**HORIZONTAL DIRECTIONAL DRILL ANALYSIS
WALTONVILLE ROAD CROSSING
PADEP SECTION 105 PERMIT NO.: E22-617
PA-DA-0056.0000-RD
(SPLP HDD No. S3-0080-16)**

The 16-inch pipeline HDD is referred to herein as HDD S3-0080-16.

ORIGINAL HORIZONTAL DIRECTIONAL DRILL DESIGN SUMMARY: 16-INCH

HORIZONTAL DIRECTIONAL DRILL REDESIGN

Figure 1A. Permitted 16-Inch HDD Plan and Profile with 20-Inch IR Data

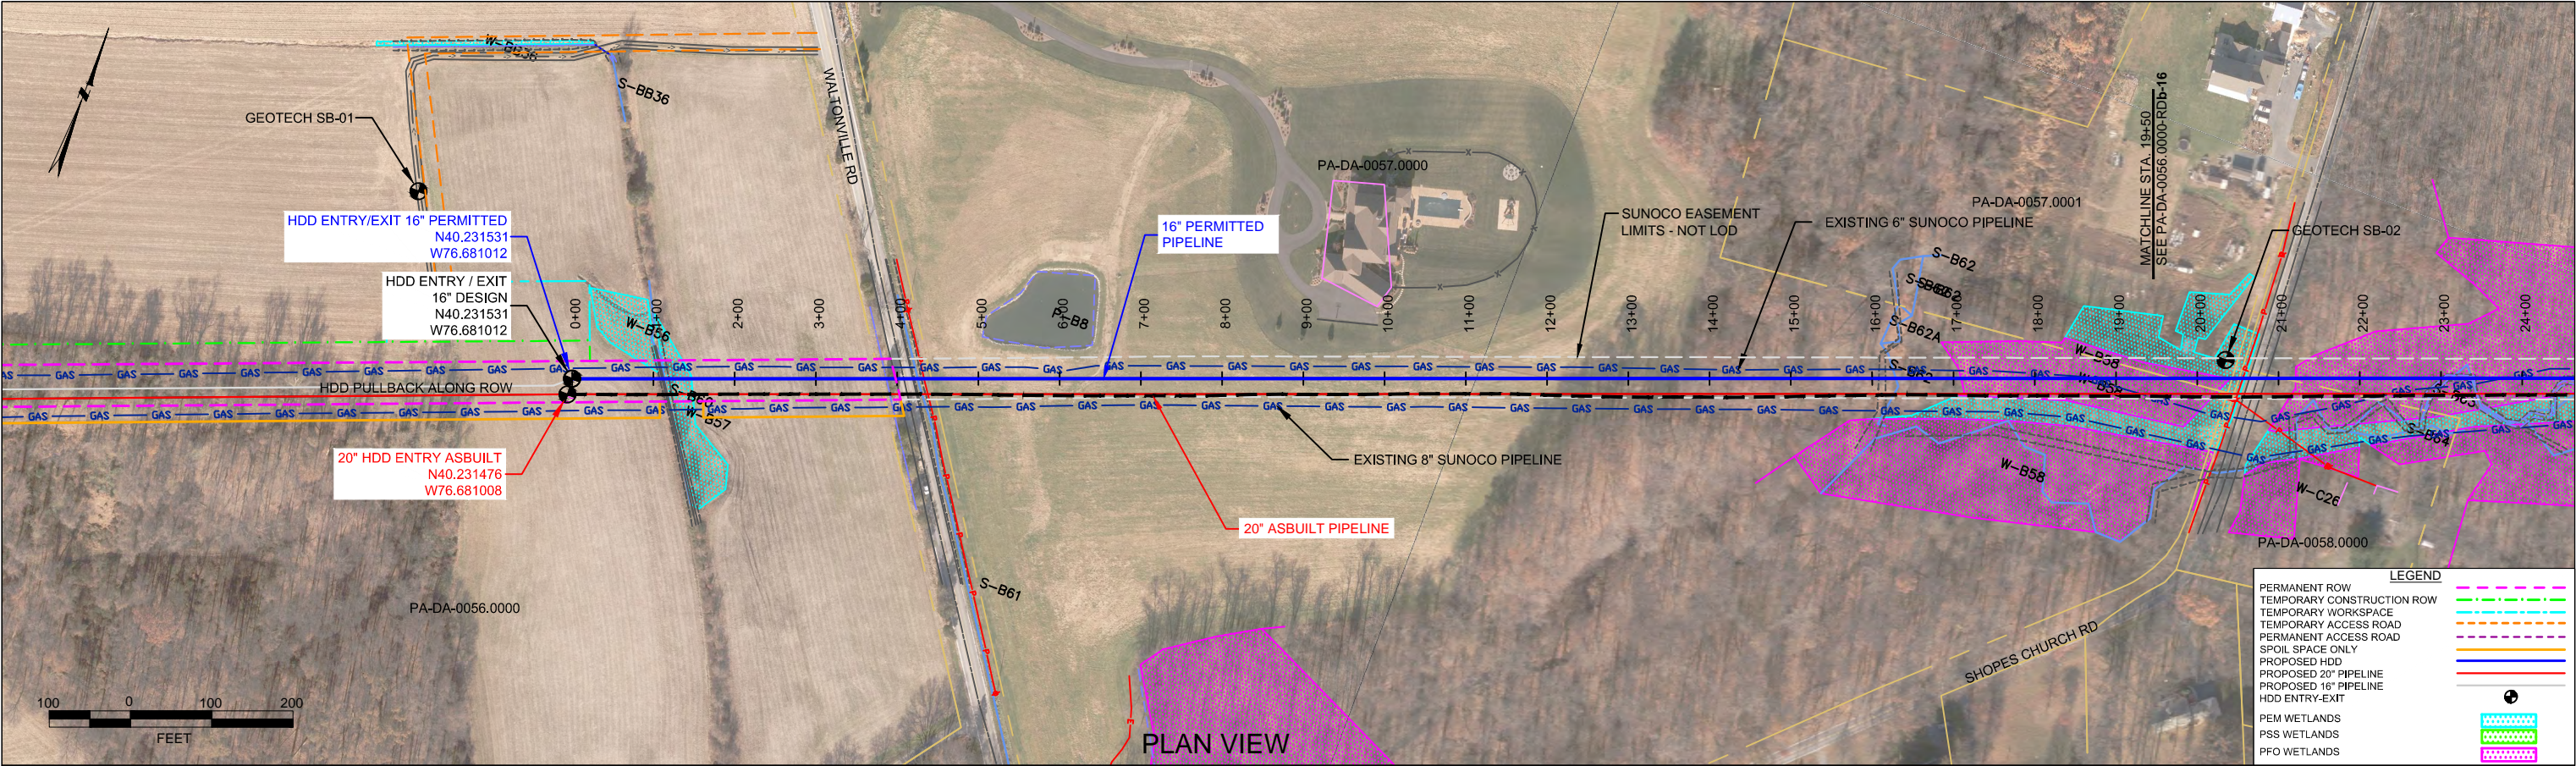
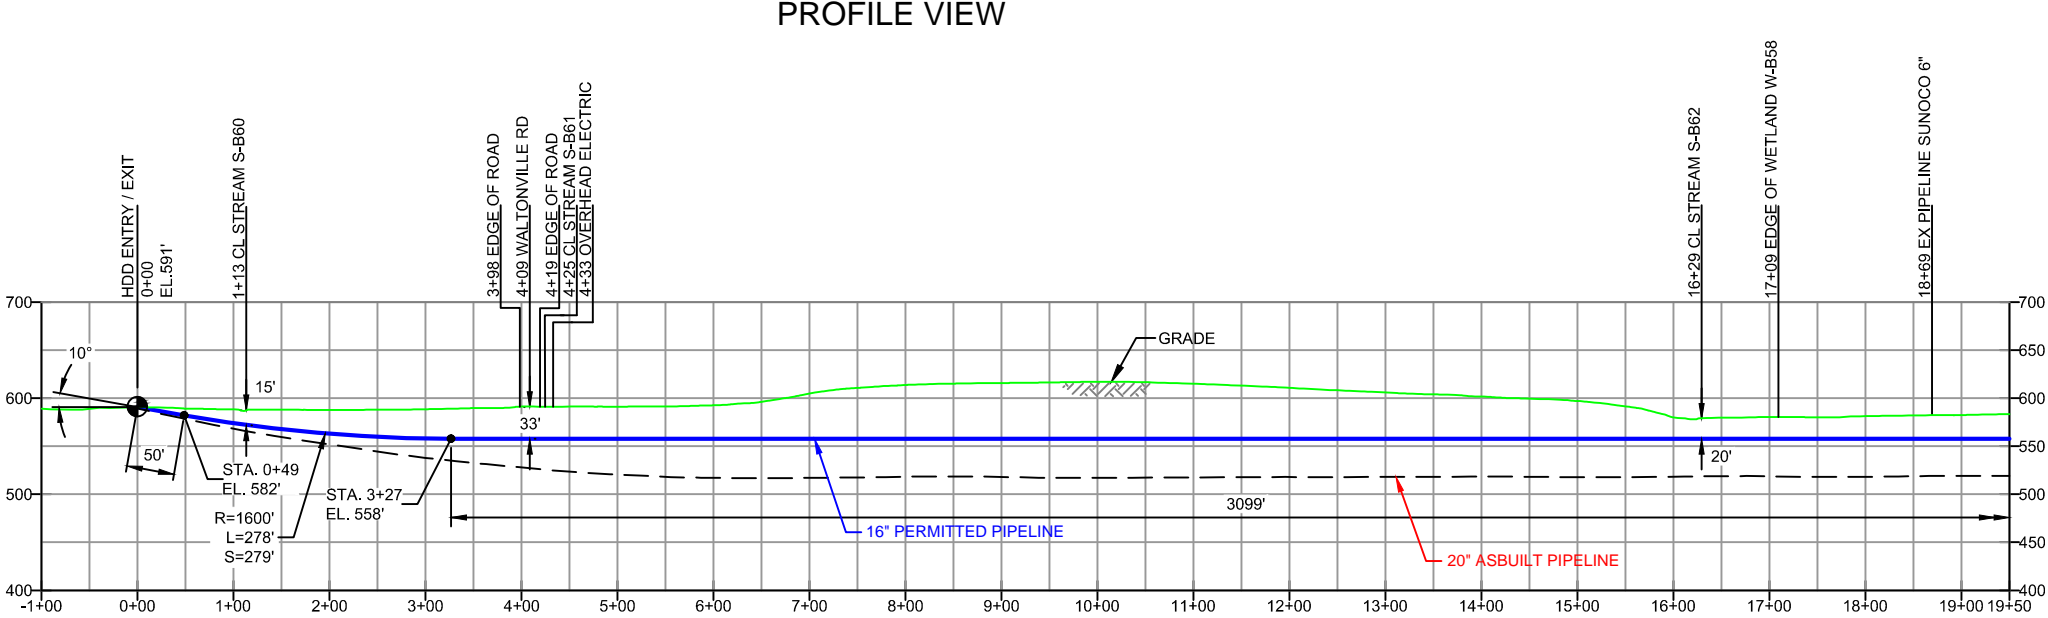
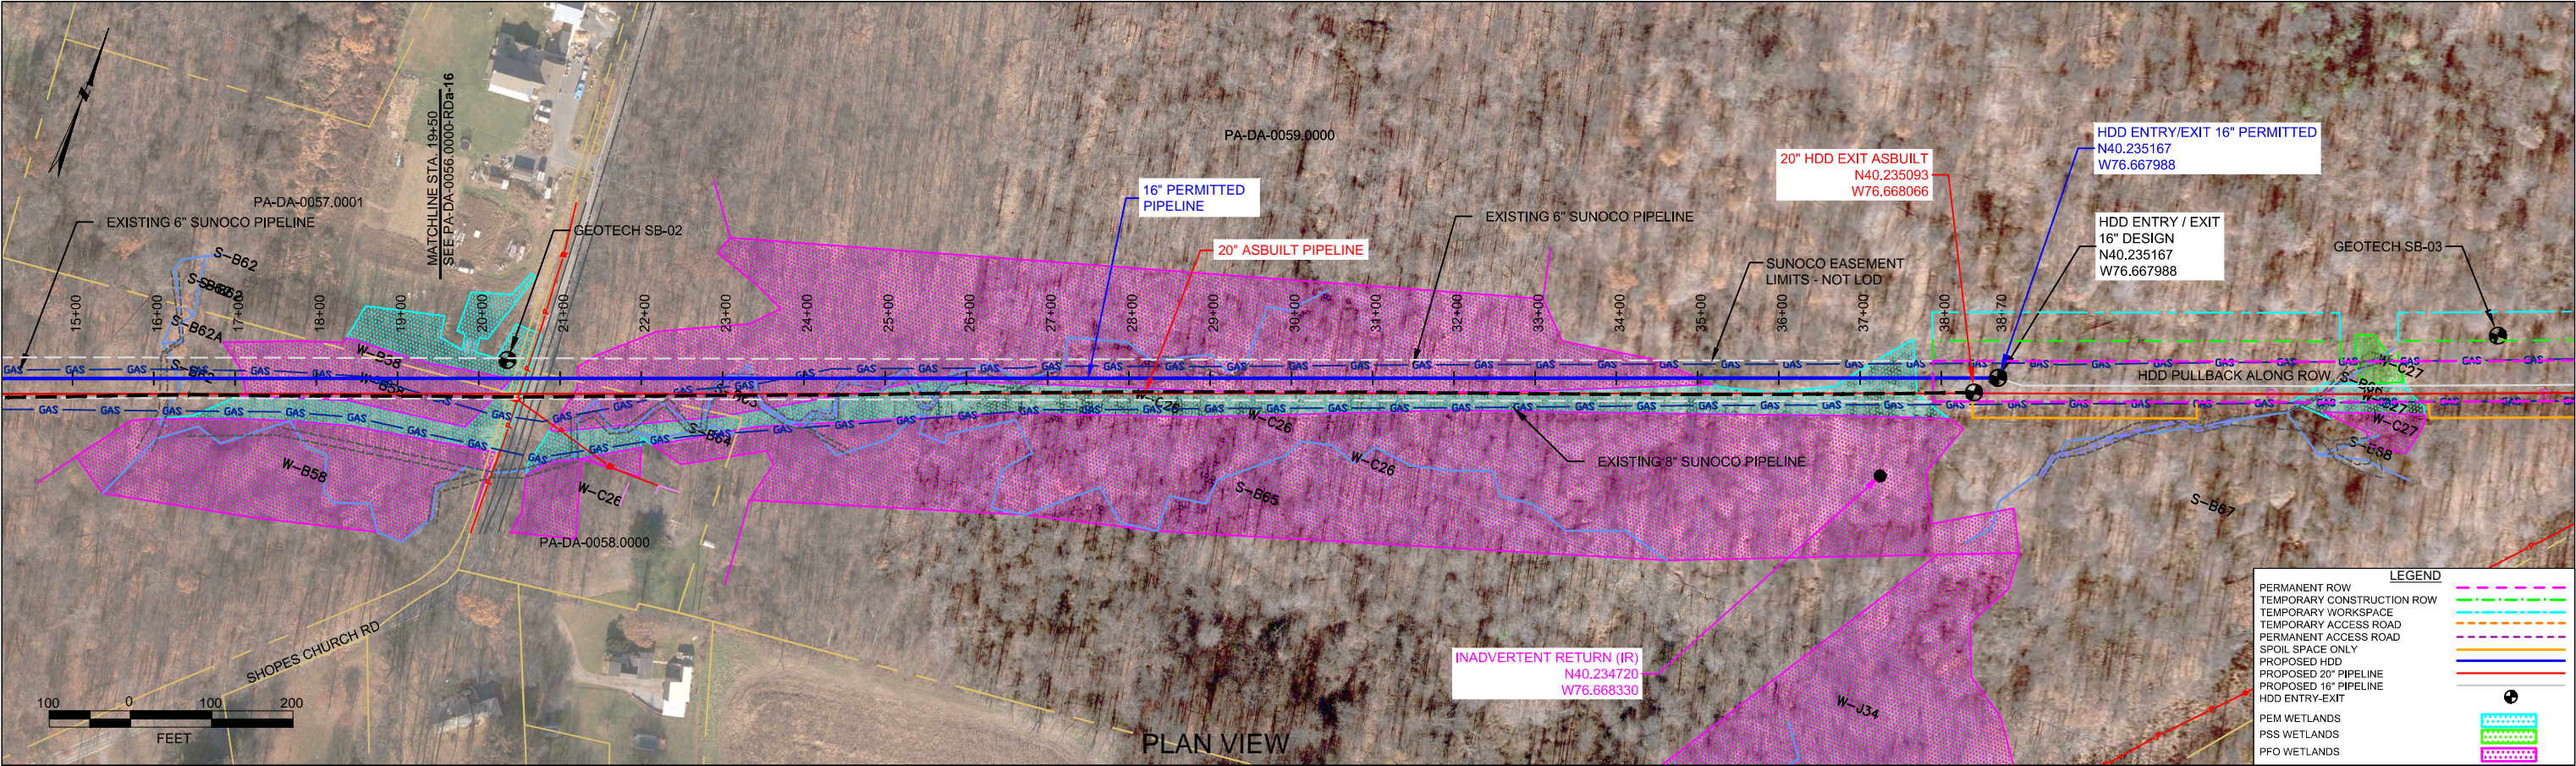
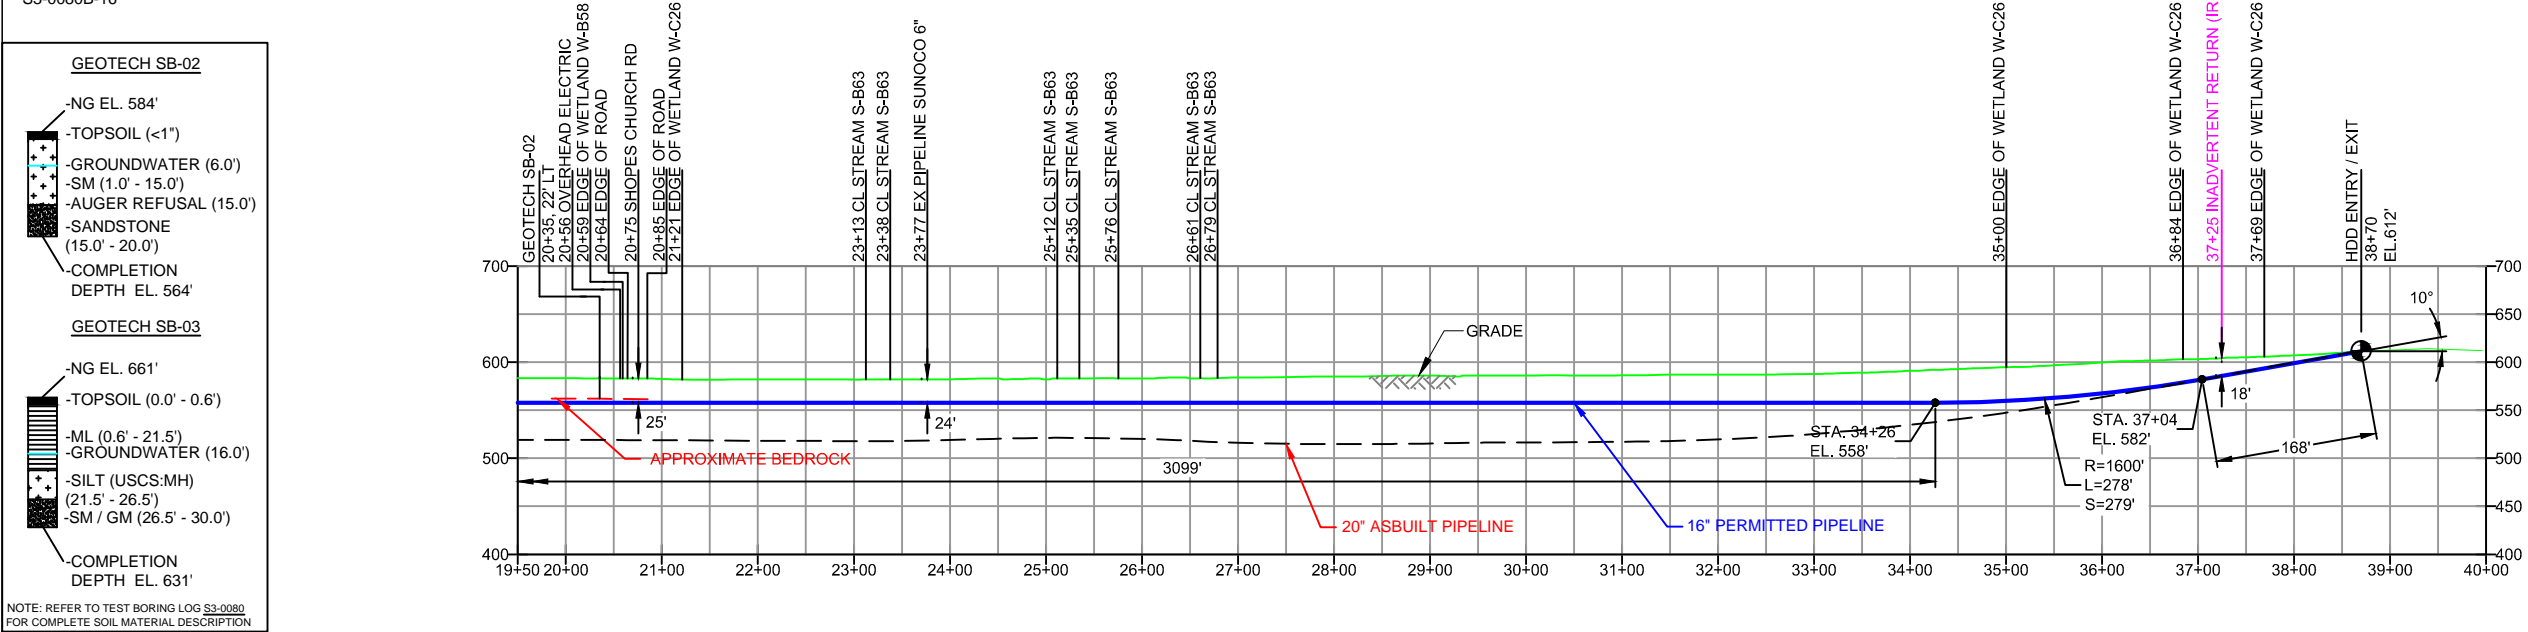
Punch out IRs are difficult to prevent. Regardless, SPLP drilling specialists have modified the profile for the 16-inch pipeline to increase the depth of profile, and increase the angles of entry and exit to reduce the potential for IR events during the drilling phases for completion of the second pipeline installation.

A summary of the redesign factors is provided below. The original and redesigned HDD plan and profile drawings are provided in Attachment 2.

Revised Horizontal Directional Drill Design Summary: 16-inch
